Meeting with the BWROG
to discuss steam dryer
integrity

BWR Steam Dryer Update

Response to NRC Questions on SIL 644 Supplement 1

Basic GE Steam Dryer Hood Types

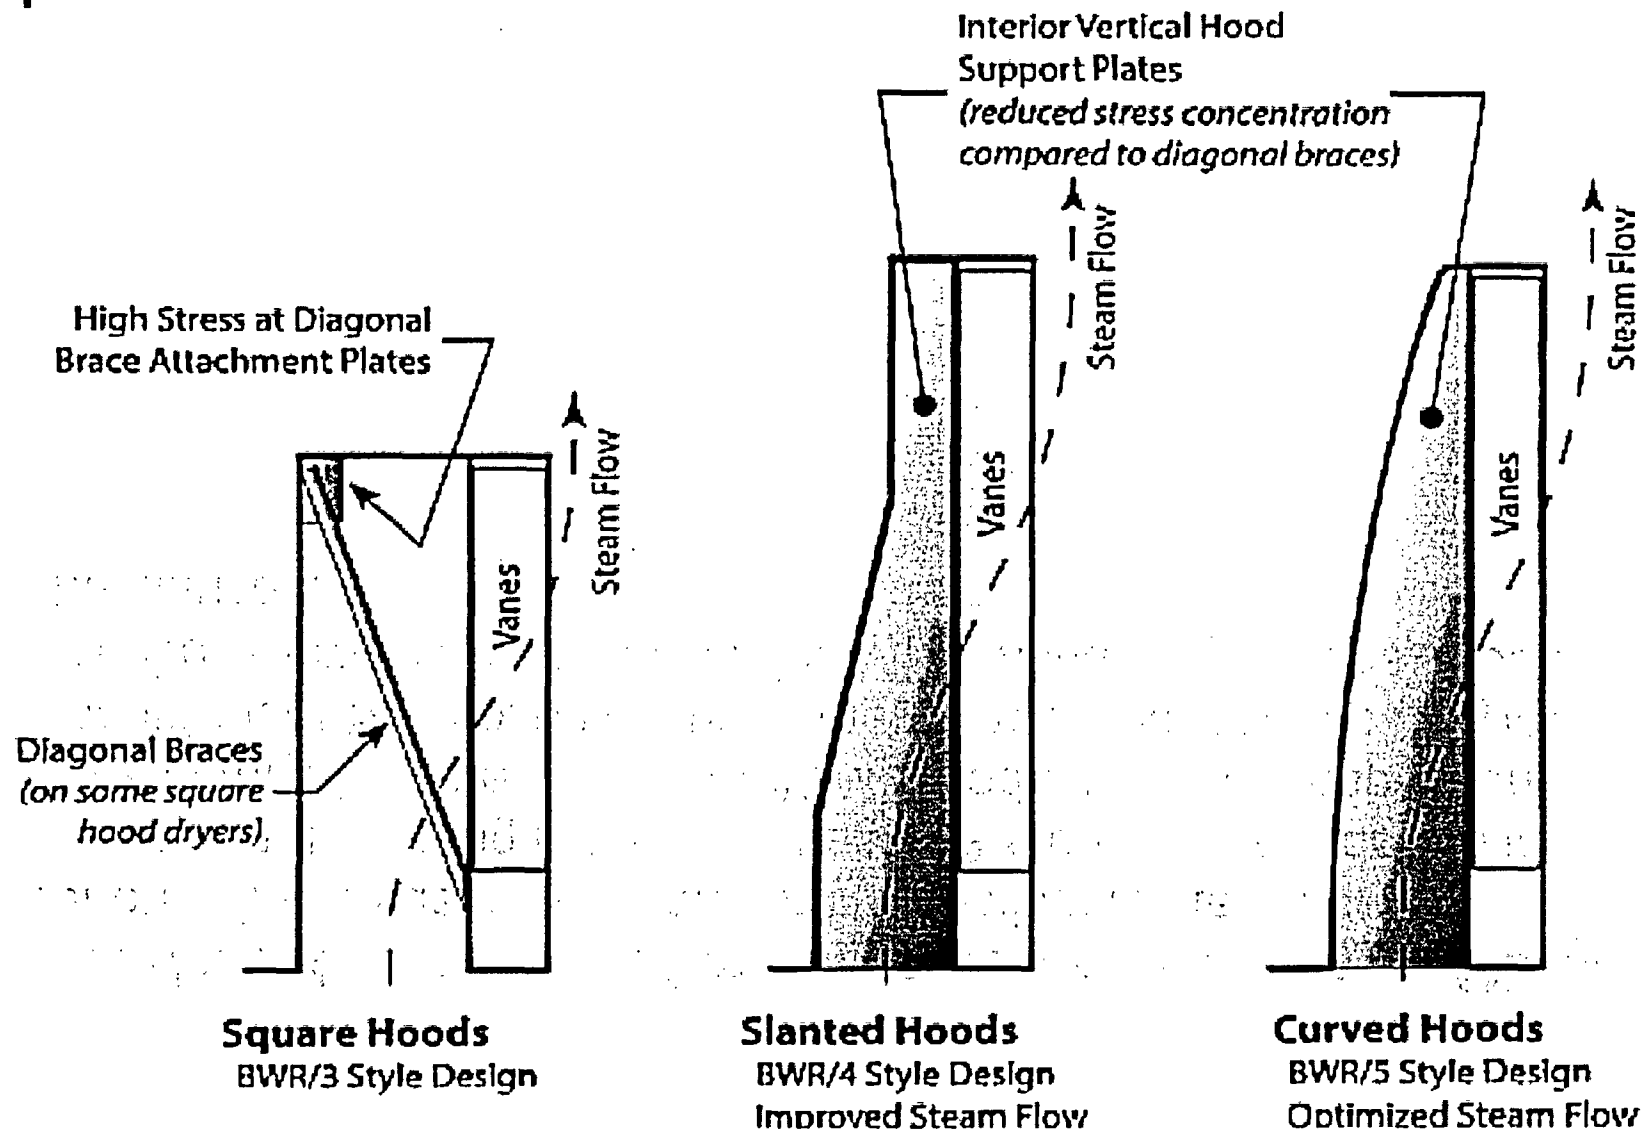
- The basis for the applicability of internal steam dryer inspection recommendations in SIL No. 644, Supplement 1 only to the BWR/3 steam dryer design with internal braces is not apparent in that experience has suggested that cracking might initiate on the interior surface of the steam dryer.

- Internal inspections recommended only for BWR/3 with internal diagonal braces
 - Interior brace attachment bracket forms localized stress concentration on inside surface of hood
 - Crack initiation observed at this location in two BWR/3s
 - Location predicted by structural analysis
- External inspections recommended for later dryer designs
 - No internal bracket forming stress concentration
 - Single-sided groove or fillet weld specified
 - Full weld penetration or backside welds not required
 - May be difficult to distinguish potential crack from crevice area in weld root

Dryer Structural Analysis Process

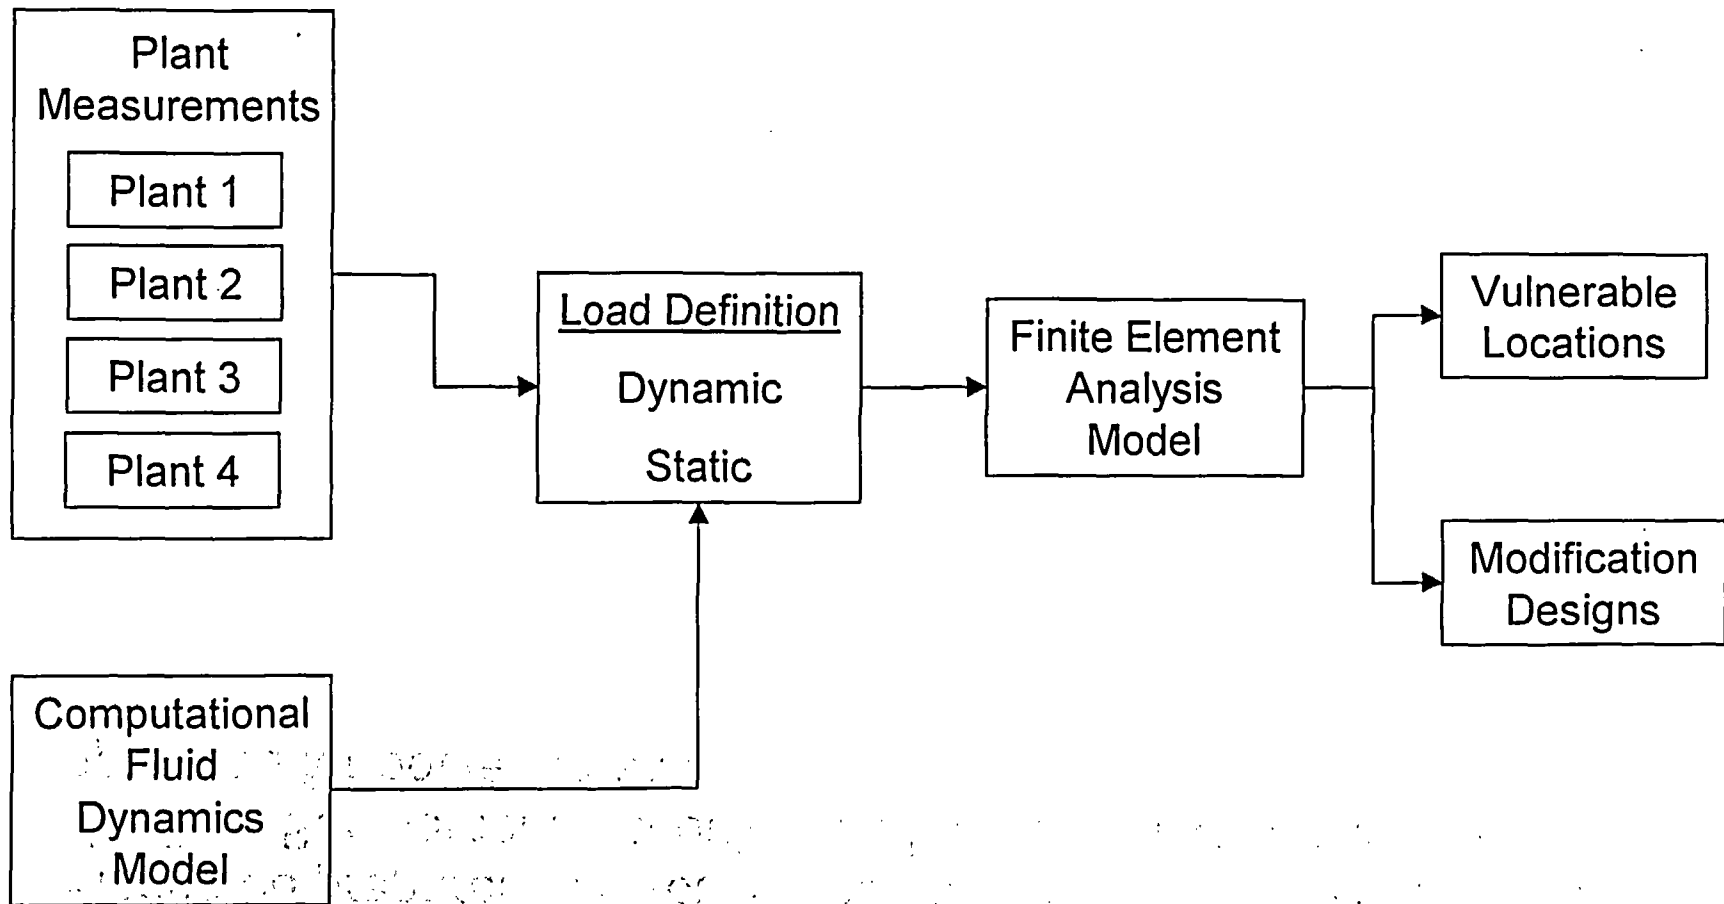
- With regard to power uprates, please be prepared to discuss what actions you intend to propose for BWRs planning to apply for future power uprates (i.e., measurement uncertainty recapture, stretch, and extended).

- GENE is developing predictive analytical techniques in support of future power uprates
 - Dynamic load definition based on in-plant measurements of several instrumented dryers
 - Computational fluid dynamics model for detailed static load distribution
 - Finite element structural analysis model of entire dryer
 - Benchmark against OLTP conditions
 - Identify vulnerable components
- Process applicable to any size power uprate
- Experience with initial EPU applications may justify simpler analysis for stretch, MUR uprates
